From: James Cox
Sent: 28 March 2019 08:13
To: Rob Smith
Subject: Woodsmith Mine - NYM/2019/0129/NM [NLP-DMS.FID262297]

Please find attached revised drawings the Production Shaft and Service Shaft buildings that reflect the on-site discussions held on 08/03 and 21/03. The revised plans reflect the following tweaks:

The attached plans replace the following that were originally submitted as part of the S96a application:

Project: 653 York Potash
Drawing Title: Mining Buildings Elevation Study - Colour
Scale: 1 : 50 @ A1
Drwg. Created: June 2014

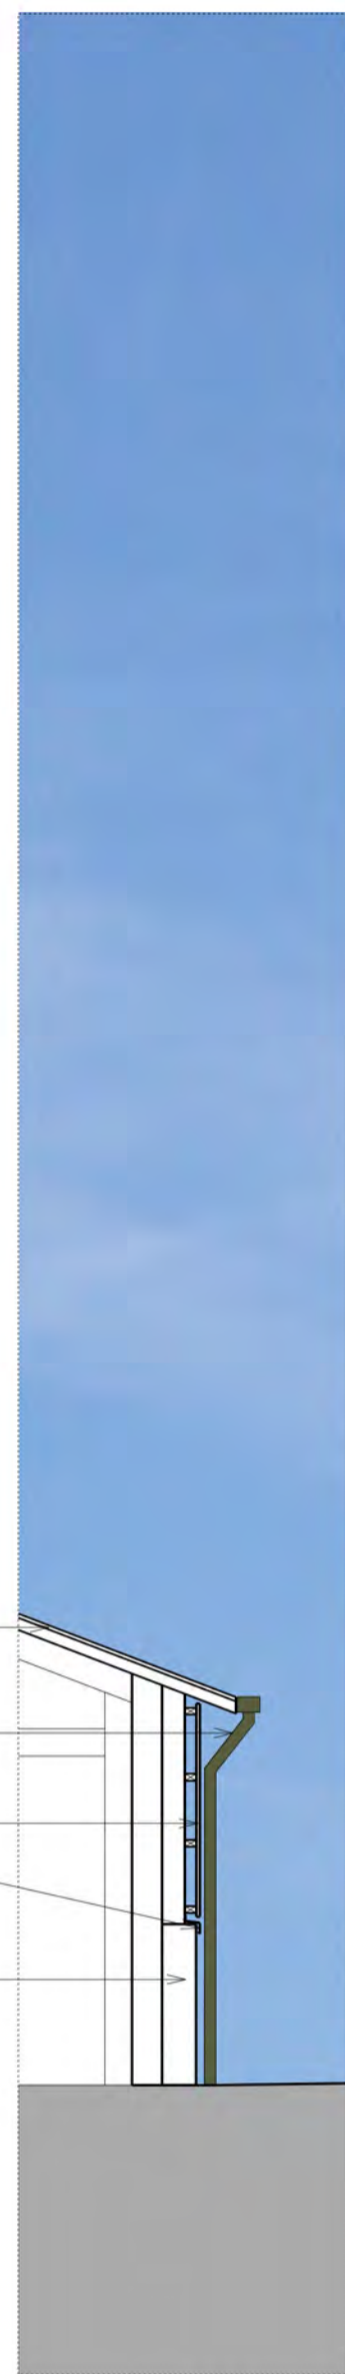
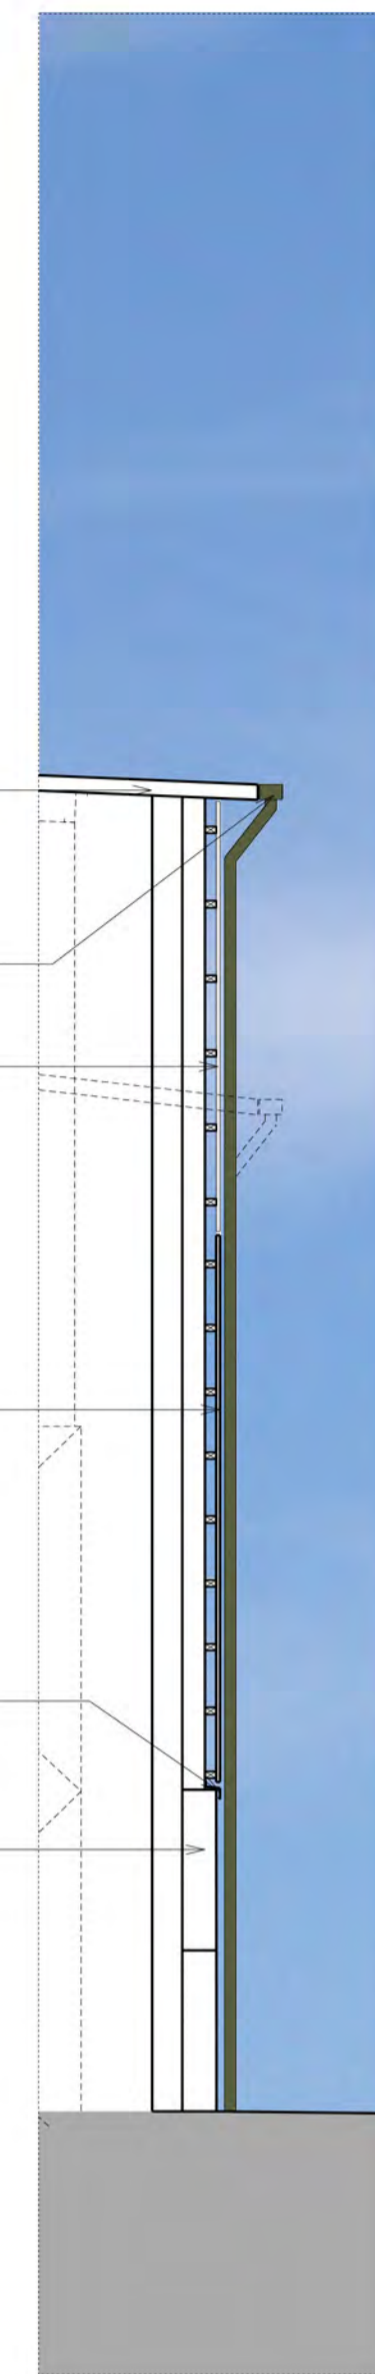
- A dark green (RAL 160 20 10) finish to the roof. This will have a non-reflective finish that will continue to dull down once it has been subjected to weather.
- Uniform wide timbers to the bottom section of the elevation;
- The retention (and slight extension) of the narrow timber board cladding to the top section of the elevation;
- Grey internal cladding;
- Light grey finishes to windows, louvres, doors etc to blend in with the natural aging of the timber; and
- A darker finish to the cement blocks.
